Re: Soil, Geology, and Geologic Hazard Study - Addendum  
Midtown at Hannah Ridge, Filing No. 3  
Akers Drive and Constitution Avenue  
El Paso County, Colorado

This letter is written in response to the Colorado Geological Survey (CGS), January 10, 2022, review comments concerning the Soil, Geology, and Geologic Hazard Study for the above referenced site, dated April 20, 2020. This addendum letter should be used in conjunction with the original Soil, Geology, and Geologic Hazard Study.

#### **CGS COMMENTS AND ENTECH ENGINEERING, INC. RESPONSES**

GEOLOGY/ENGINEERING GEOLOGY MAP  
MIDTOWN AT HANNAH RIDGE, FILING NO. 3  
AKERS DRIVE AND CONSTITUTION AVENUE  
EL PASO COUNTY, CO.  
FOR: ELITE PROPERTIES OF AMERICA, INC.

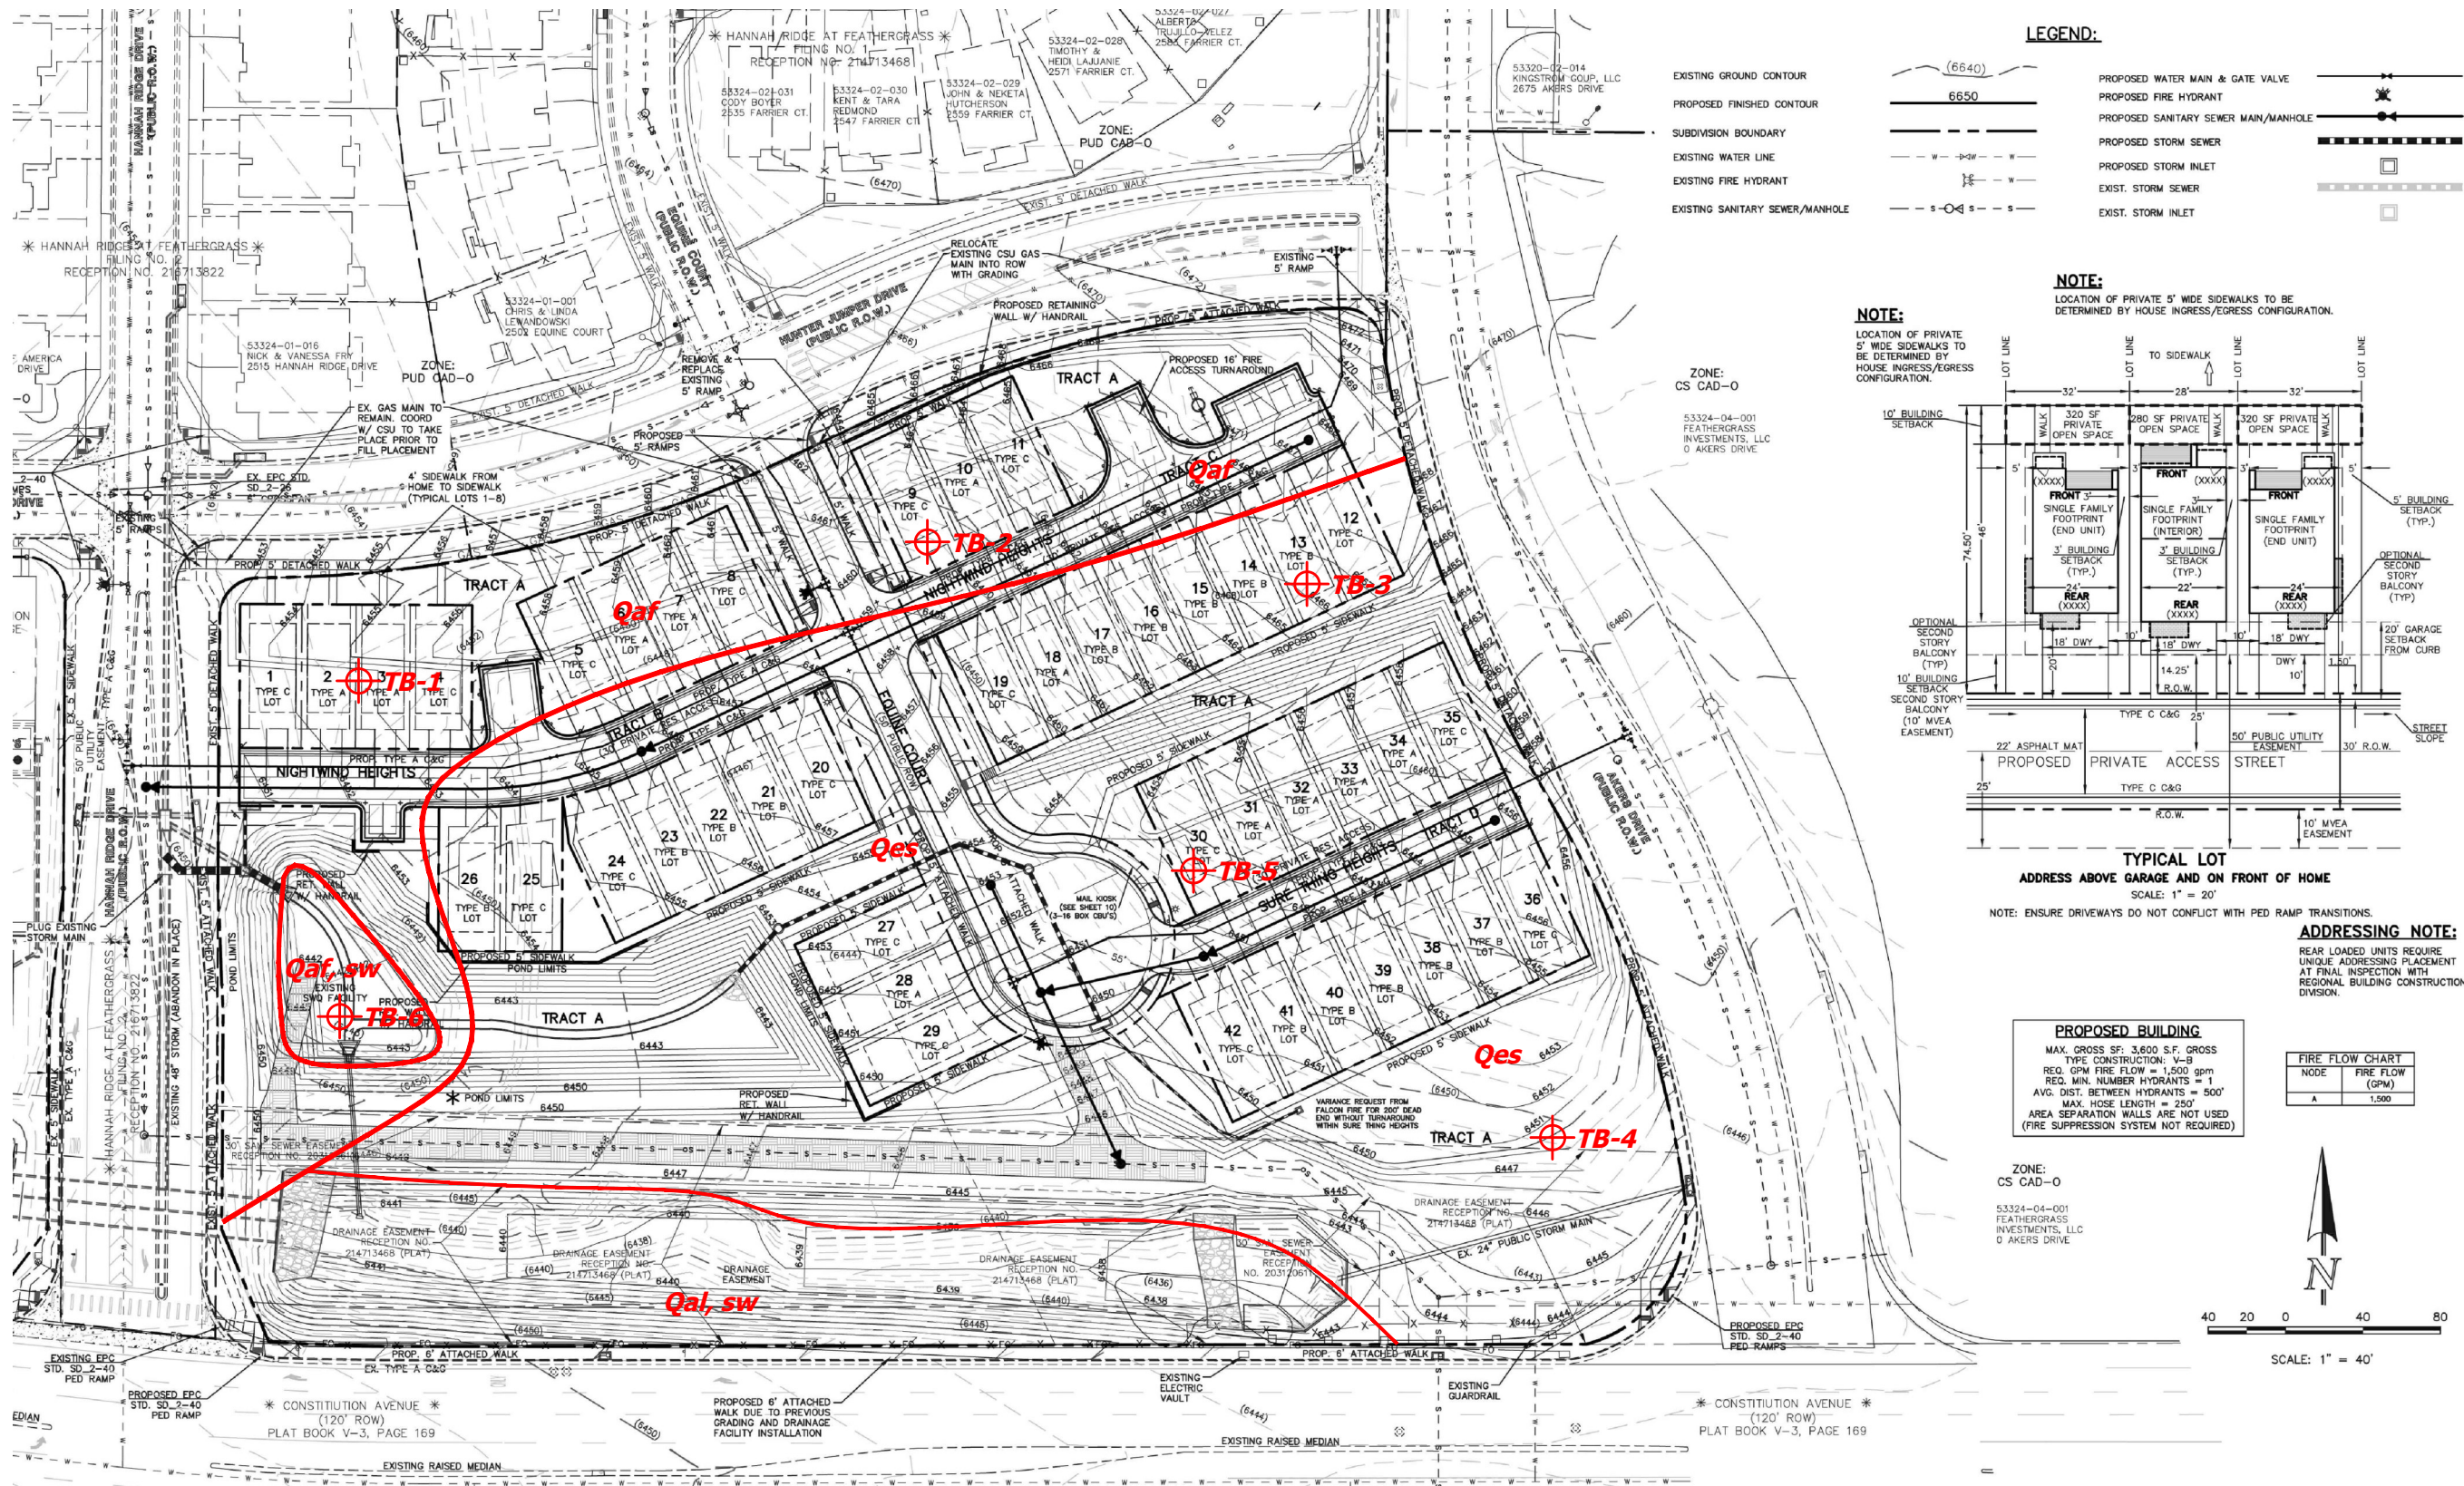
**CGS Comment:** *"Basement feasibility: Since it appears that not all areas of high groundwater will be avoided by construction, CGS recommends that Entech be provided the opportunity to map areas of high groundwater, list the lots impacted by high groundwater, and provided recommendations for any needed underground drainage system. We recommend that Entech discuss the feasibility of basements due to the anticipated high groundwater."*

**Entech Response:** The proposed development does not have basements or crawlspaces, and will utilize shallow spread footings with slab on grade construction. Entech has updated the Geology/Engineering Geology Map (Figure 1), with the latest site plan with proposed grading. The areas mapped with the potential for seasonal shallow groundwater are located in the existing detention pond, and the drainage along the southern side of the site. Groundwater was encountered in four of the six test borings drilled on the site at depths of 5 to 18 feet. The proposed structures are not located in the areas of mapped as seasonally wet areas.
